**CITY OF SEATTLE
ANALYSIS AND DECISION OF THE DIRECTOR
OF THE DEPARTMENT OF DESIGN, CONSTRUCTION AND LAND USE**

Application Numbers: 9808607

Address of Proposal: 3120 Harvard Avenue East

Master Use Permit to establish the use for the future construction of a six-story mixed use building with 2,747 square feet of retail at ground level, ten apartment units above and accessory parking for 12 vehicles. Project includes grading of 1,200 cubic yards of material.

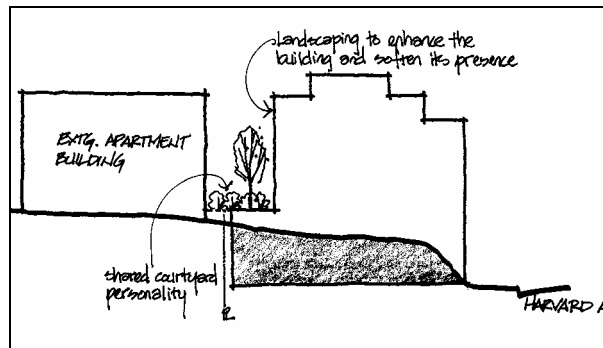
The Board was encouraged by the architect's street level concept plan that calls for a corner entry plaza into commercial unit 'A' at the site's northwest corner, and separate entrances for the residential units and commercial unit 'B' on Harvard Avenue East. Further design should continue in this direction.
